UN/SCETDG/51/INF.7/Add.1 UN/SCEGHS/33/INF.3/Add.1

Revision of the Manual of Tests and Criteria: Part I: Section 10

**Transmitted by the Chairman of the Working Group on Explosives on
behalf of the Working Group**

This document takes account of the amendments to the 6th revised edition of the Manual of Tests and Criteria adopted by the Committee at its eighth session (see ST/SG/AC.10/44/Add.2).

Figure 10.7: PROCEDURE FOR PROVISIONAL ACCEPTANCE OF **HEXANTROSTILBENE MUSK XYLENE** IN **THE CLASS 1-OF EXPLOSIVES**

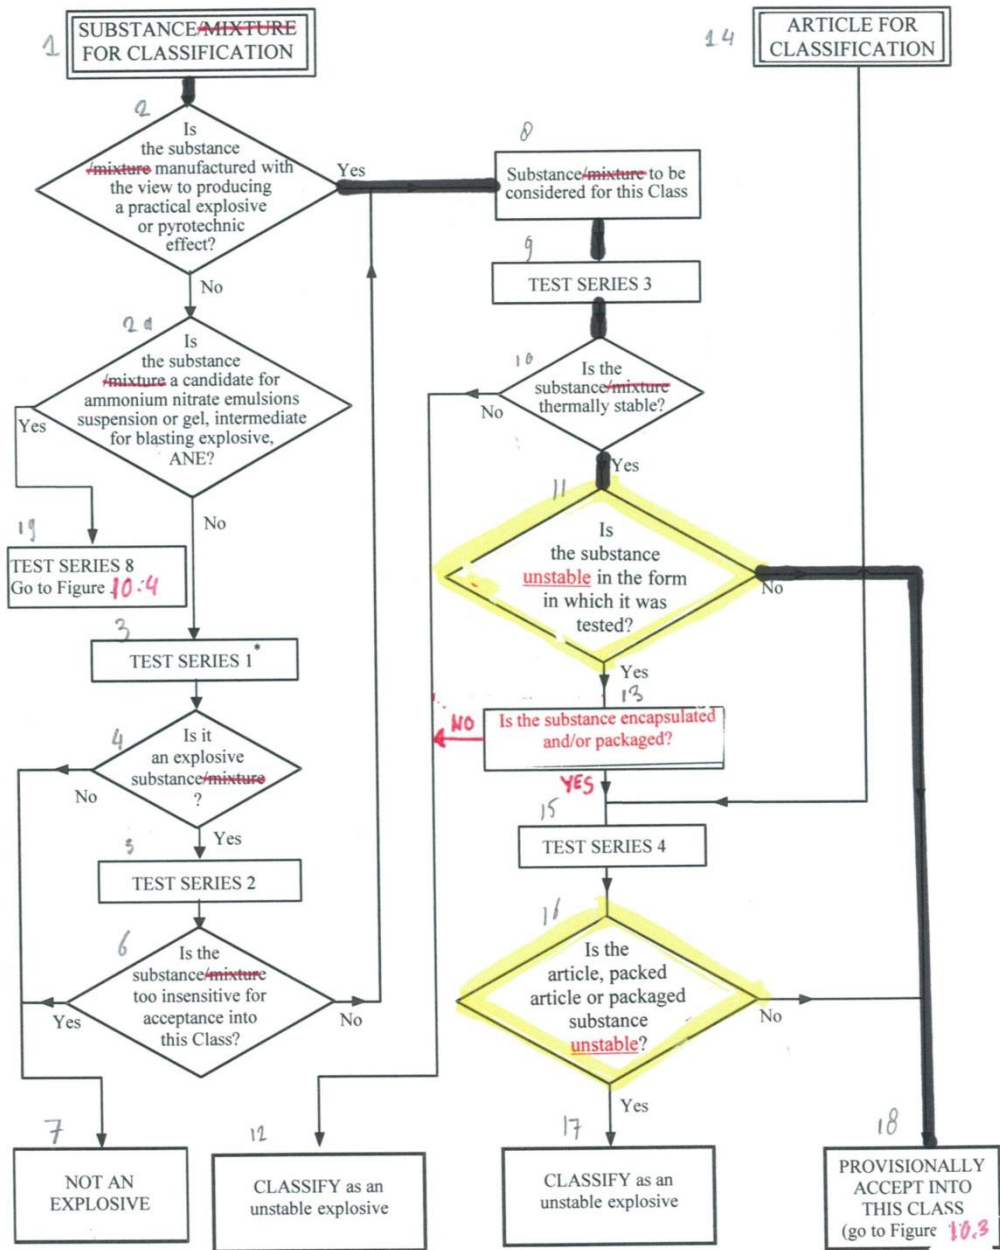
1. **Name of substance:** Hexanitrostilbene ~~5 tert-BUTYL-2,4,6-TRINITRO-m-XYLENE (MUSK-XYLENE)~~
2. **General data**
- 2.1 Composition: hexanitrostilbene ~~99% tert-butyl-2,4,6-trinitro-m-xylene~~

- 2.2 Molecular formula: C₁₄H₆N₆O₁₂ ~~C₁₂H₁₅N₃O₆~~
- 2.3 Physical form: Fine-crystalline ~~powder~~
- 2.4 Colour: Pale-yellow ~~orange~~
- 2.5 Apparent density: 840-1700 ~~kg/m³~~

- 2.6 Particle size: 0.1 – 0.3 ~~< 1.7~~ mm
3. **Box 2:** Is the substance manufactured with the view to producing a practical explosive or pyrotechnic effect?

- 3.1 Answer: No ~~Yes~~
- 3.2 Exit: Go to Box 3 ~~8~~
4. ~~Box 3:~~ Test Series 1
- 4.1 ~~Propagation of Detonation:~~ UN-gap test (test 1(a))
- 4.2 ~~Sample conditions:~~ Ambient temperature

Figure 10.9: PROCEDURE FOR CLASSIFICATION OF HEXANITROSTILBENE IN THE CLASS OF EXPLOSIVES
~~EXEMPTION OF MUSK XYLENE FROM CLASS 1~~
~~PROCEDURE FOR CLASSIFICATION OF HEXANITROSTILBENE IN THE CLASS OF EXPLOSIVES~~

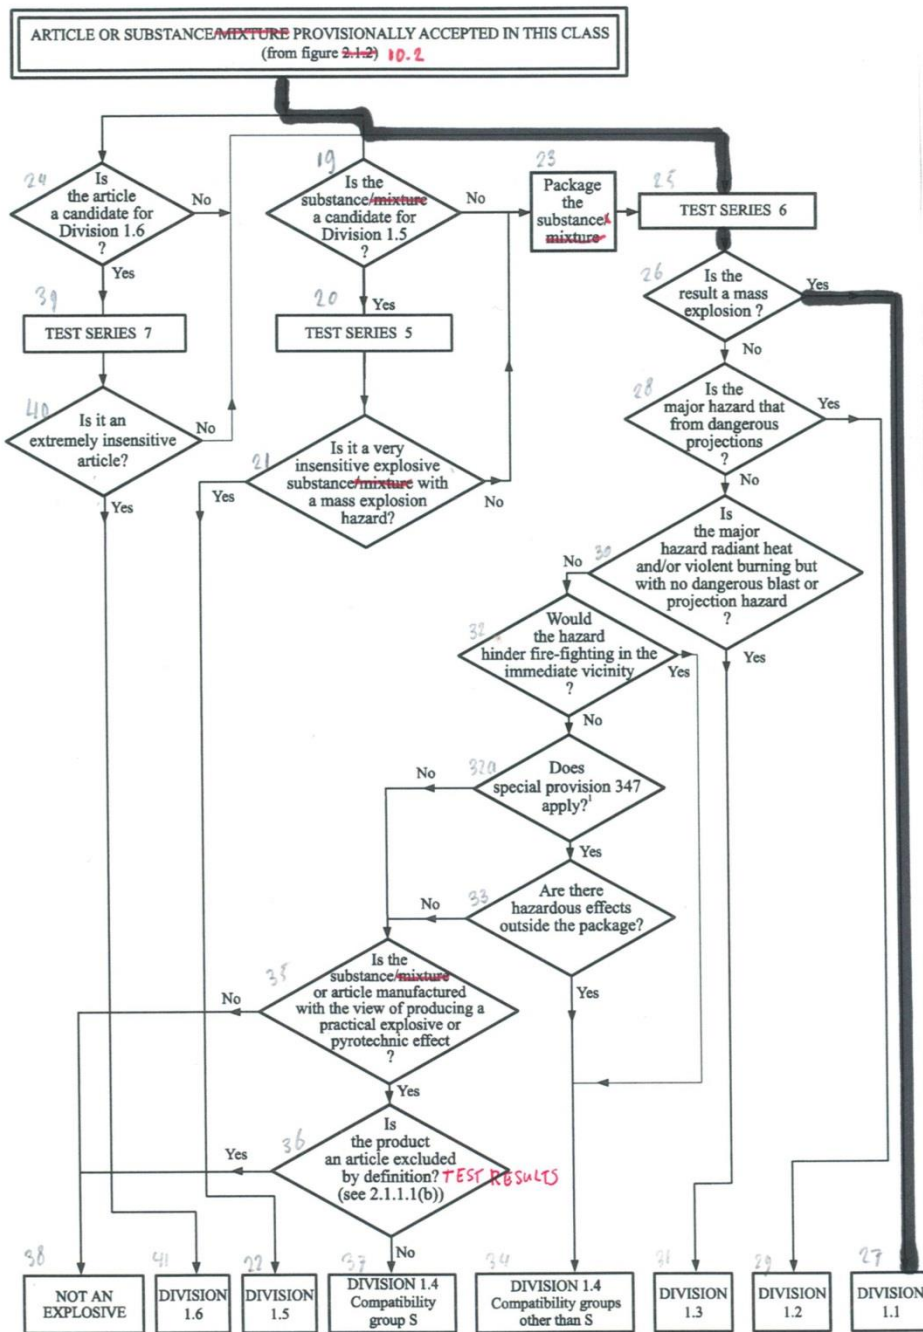
2.1 Effect of initiation in the package:	Test 6(a) with detonator
2.2 Sample conditions:	Ambient temperature, 50 kg fibreboard drum
2.3 Observations:	Detonation, crater Only localised decomposition around detonator

2.4 Result:	Mass explosion No significant reaction
2.5 Effect of ignition in the package <u>between packages</u> :	Test 6(a) <u>with detonator</u> with igniter

2.6 Sample conditions:	Ambient temperature, 50 kg <u>3</u> fibreboard drums
2.7 Observations:	Detonation, crater Only localised decomposition around igniter

2.8 Result:	Mass explosion No significant reaction
2.9 Effect of propagation between packages:	Type 6(b) test not required as no effect outside package in 6(a) test

3.1 Answer from Test Series 6	No <u>Yes</u>
3.2 Exit	Go to box 28 <u>27</u>
4. Box 28:	Is the major hazard that from dangerous projections?
4.1 Answer from Test Series 6:	No

8.1 Answer:	No
8.2 Exit:	Go to box 38
9.4. Conclusion	<u>Assign to Division 1.1</u> NOT CLASS 1
9.1 Exit:	Consider for another class/division
